Project Status Meeting Wallowa Falls Hydroelectric Project FERC Project No. 308

November 4, 2014

Purpose of Meeting:

- to review PacifiCorp's Additional Information Request-Response filed with FERC on October 22, 2014
- to discuss enhancement measures proposed in the Final License Application
- to discuss recreation interests in the Project area

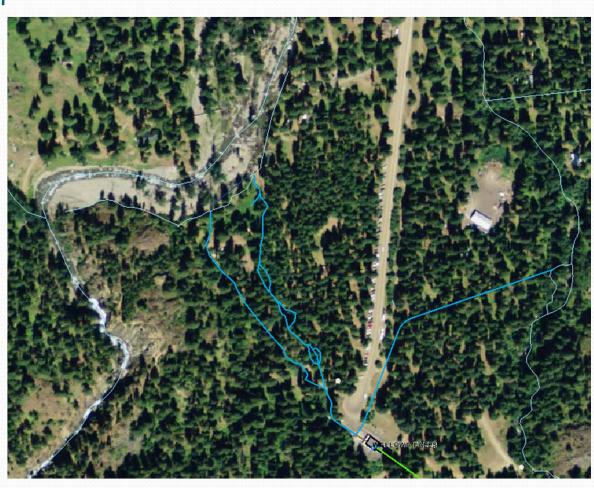
Provide an evaluation of the environmental effects, benefits, and costs of the following (five) alternatives: (1) permanently dewatering the existing tailrace channel and constructing a pipe along the existing tailrace channel alignment to convey powerhouse flows to the West Fork

- FERC alternatives 1, 2, and 3 all entail construction of new facilities in the active West Fork Wallowa River channel in order to eliminate risk of stranding ESA protected bull trout and\or bull trout redds.
- The capital costs associated with alternatives 1, 2 and 3 are prohibitively high considering the risk to damage from seasonal high flows the water conveyance system and\or outfall structure would be subject to.

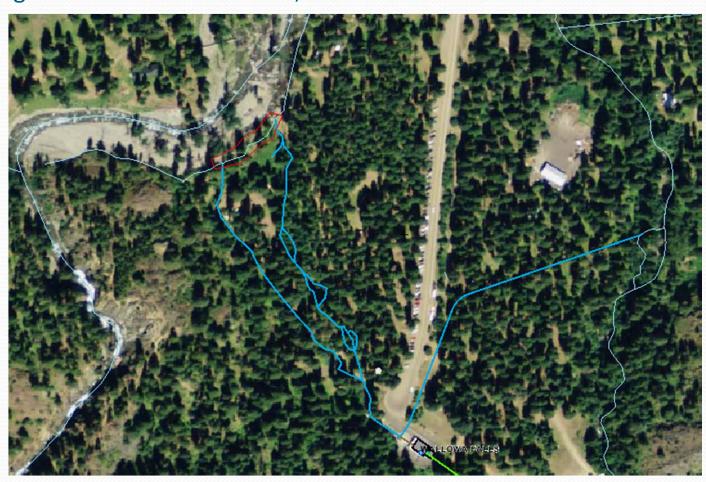
(2) continuing to use the existing tailrace channel to convey powerhouse flows to the West Fork, but constructing a permanent fish passage barrier at the existing tailrace channel confluence with the West Fork to prevent fish from migrating into the tailrace channel;

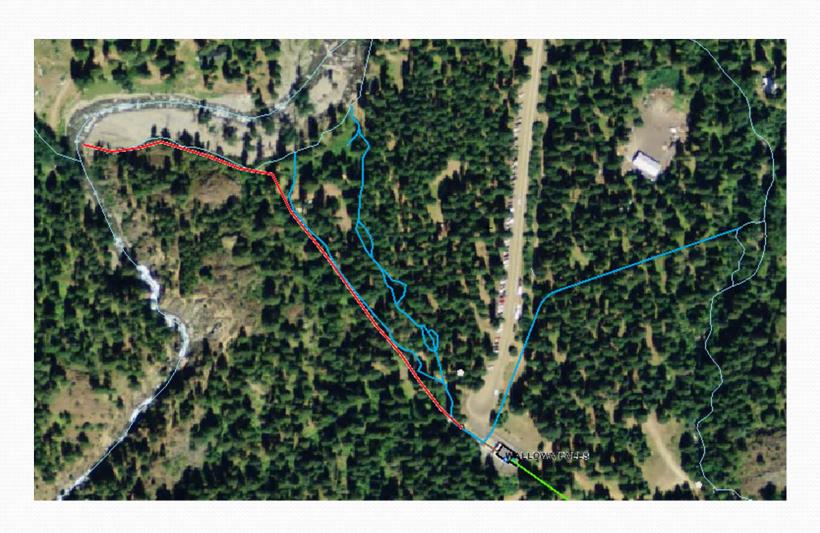
(3) permanently dewatering the existing tailrace channel and constructing a pipe along a different alignment that discharges to a more-stable channel location upstream of the current discharge location on the West Fork.

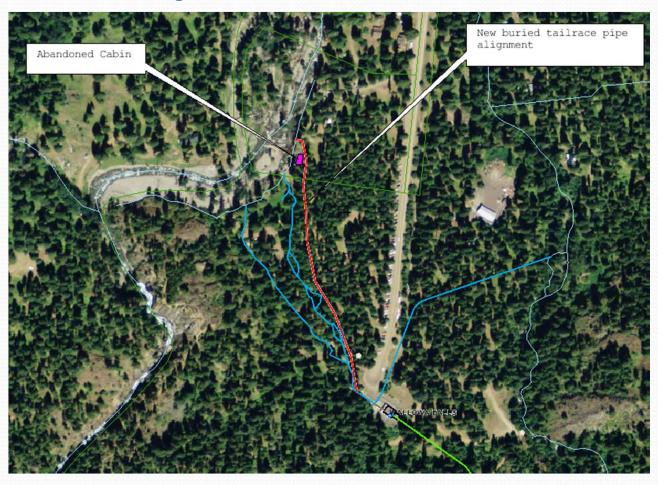
(5) construct a pipe to convey powerhouse flows that extends farther downstream of the existing tailrace channel alignment/discharge point to an area of the West Fork with a more-stable channel that wouldn't be as susceptible to channel migration.

- Capital cost would be comparable to the reroute to the East Fork Bypassed Reach (approx \$1.75 M).
- This alternative would not realize the same aquatic habitat benefits in the lower East Fork Wallowa River bypassed reach as the proposed new tailrace discharge location on the East Fork Wallowa River.
- The outfall structure associated with this alternative would be immediately adjacent to, and discharge into, the active West Fork Wallowa River channel.
- Though a detailed geotechnical evaluation of the area between the powerhouse and the West Fork has not been done, this location is likely to be much less susceptible to damage from high flow events in the West Fork compared to alternatives 1, 2, and 3 above.

PacifiCorp's Sixth Alternative (f)

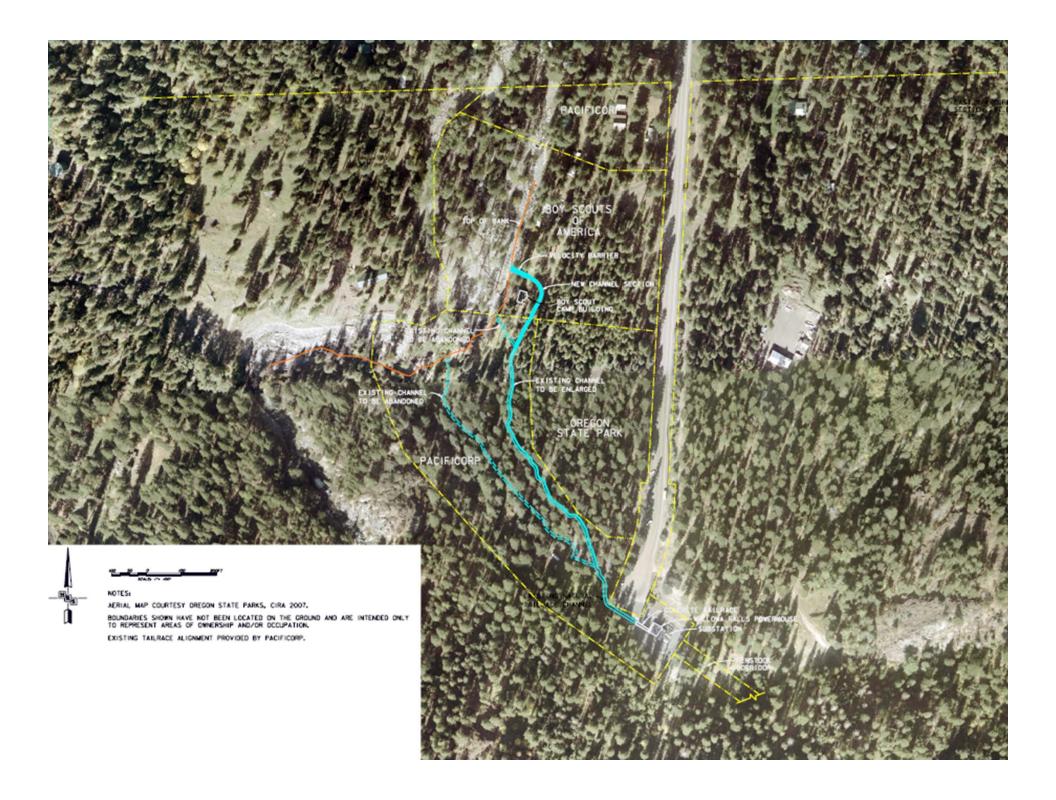
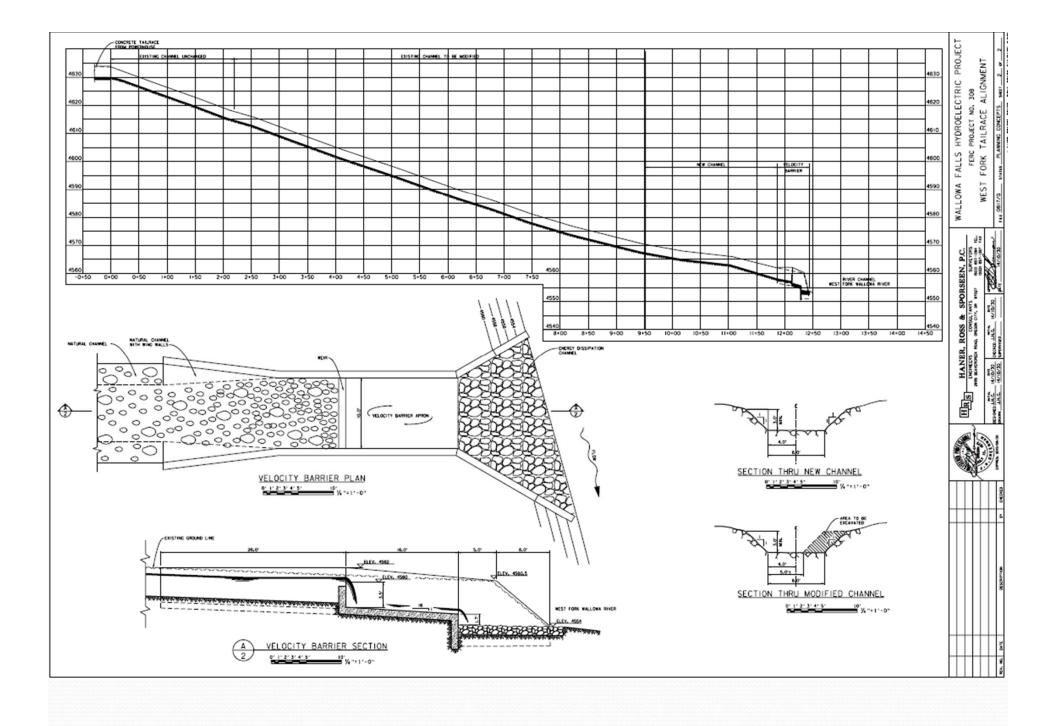
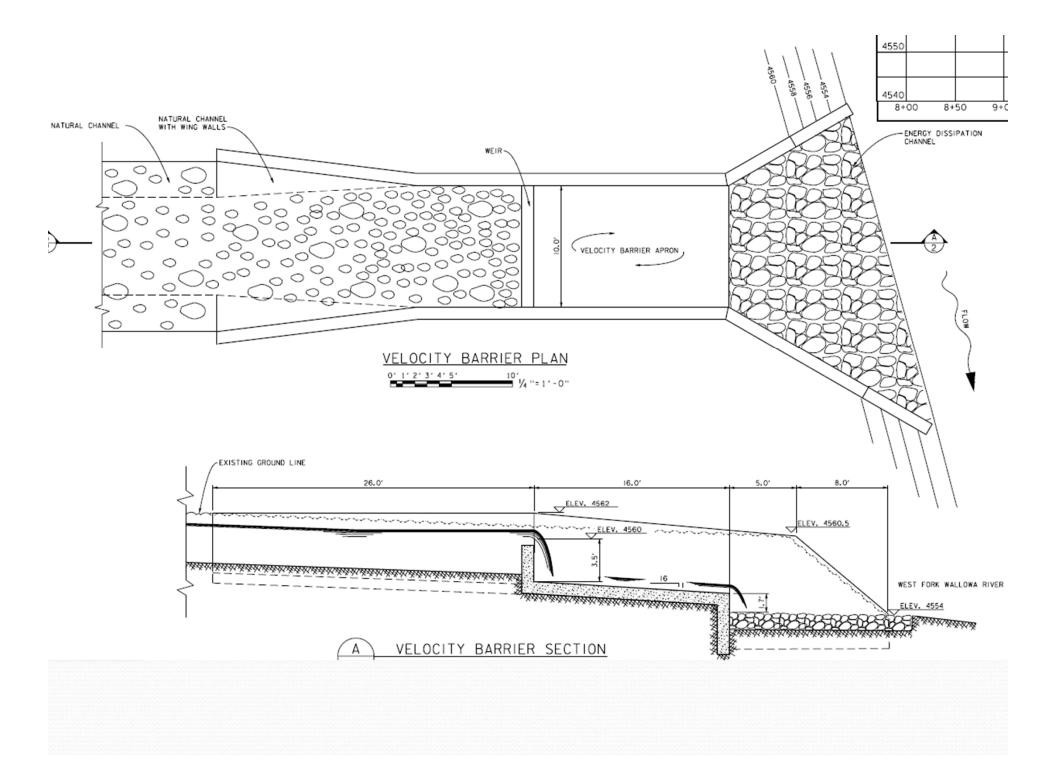
Permanently dewatering the existing tailrace channel and constructing an open excavated channel to convey powerhouse flows that extends farther downstream of the existing tailrace channel alignment/discharge point to an area of the West Fork with a more-stable channel that would not be as susceptible to channel migration:

- The existing tailrace side channel alignment would be used for much of its length.
- This alternative would include a discharge structure with a velocity barrier which meets the requirements of Section 5.4 Velocity Barriers in the 2011 NMFS Anadromous Salmonid Passage Facility Design (NMFS 2011) to prevent all fish species and life stages from entering the tailrace channel.
- Instream flow releases in the East Fork bypassed reach of a year-round flow of 4 cfs as measured at the proposed compliance gage location.
- Capital costs of this alternative are estimated to be \$850,000.
